ATTACHMENT A
CHANGED TECHNICAL SPECIFICATION PAGES

LICENSE CHANGE REQUEST SAFETY ANALYSIS

CAROLINA POWER & LIGHT COMPANY
H. B. ROBINSON
JUSTIFICATION FOR STARTUP AND OPERATION OF
H. B. ROBINSON WITH ALTERED HHSI FLOW PERFORMANCE

FIGURE 3.10-3 NORMALIZED AXIAL DEPENDENCE FACTOR FOR F_q VERSUS ELEVATION
(PEAK $F_q = 2.32$)

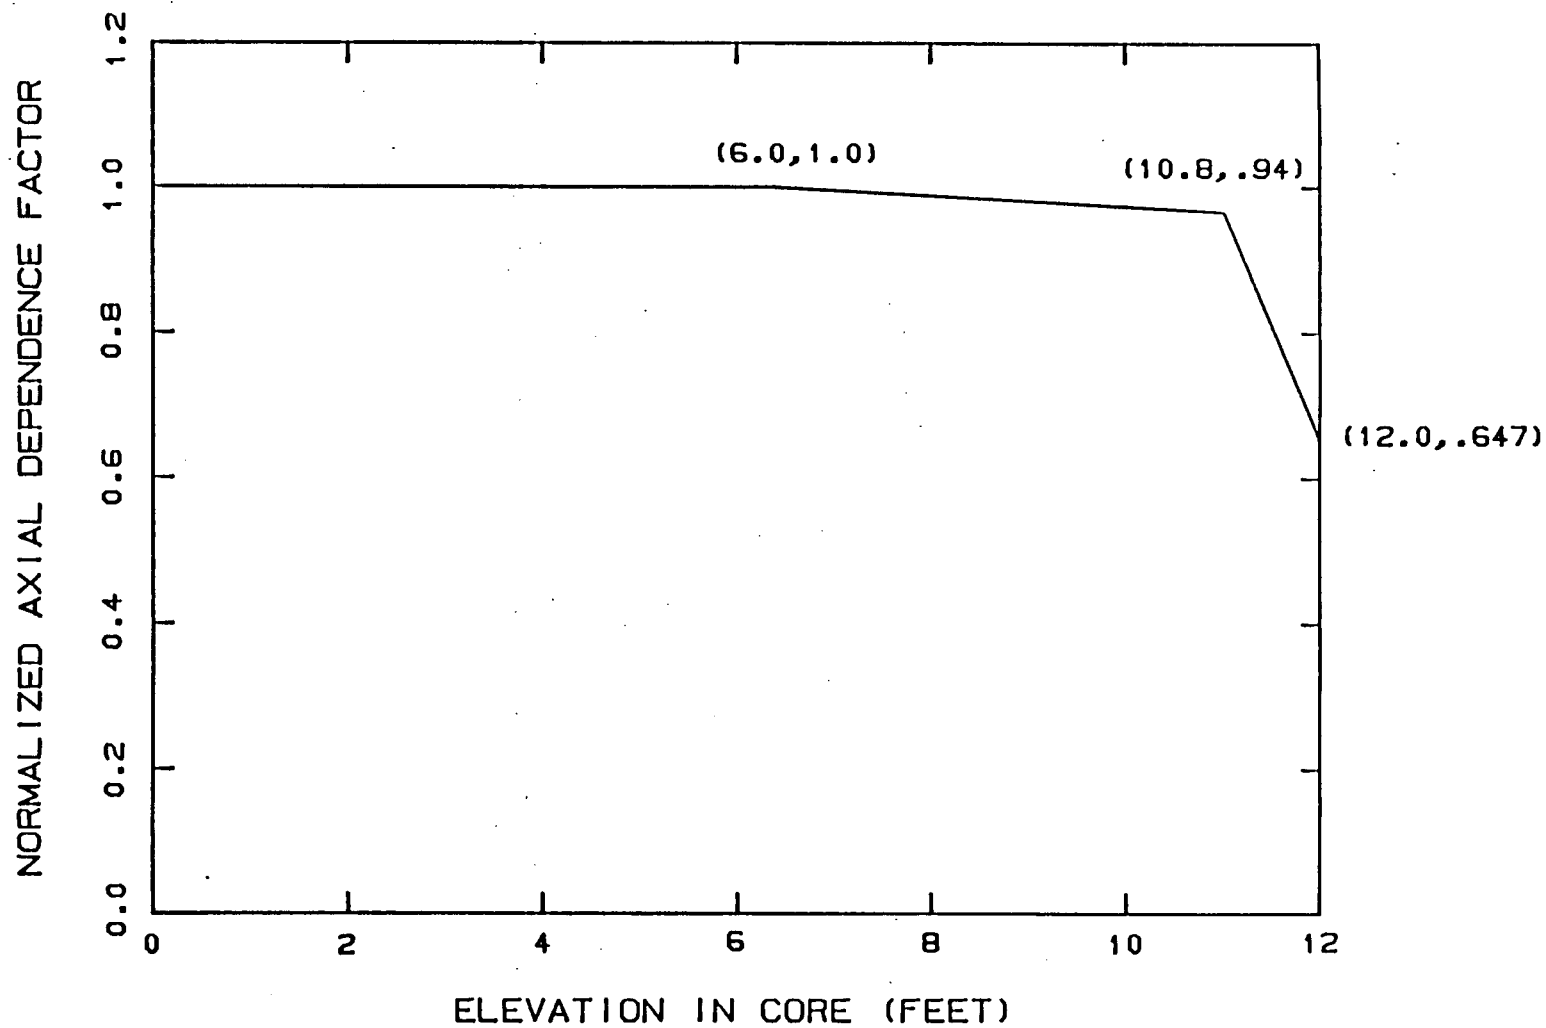
Note: With only two safety injection pumps operable, each capable of automatic initiation from a separate emergency bus, peak $F_q = 2.26$.

Although the 2.26 value for Fq was used in the Large Break LOCA analysis, 2.32 was retained as the value in the Small Break LOCA analysis. As a conservative simplification, the original shape of the K(z) curve in Tech. Spec. Figure 3.10-3 is being retained.
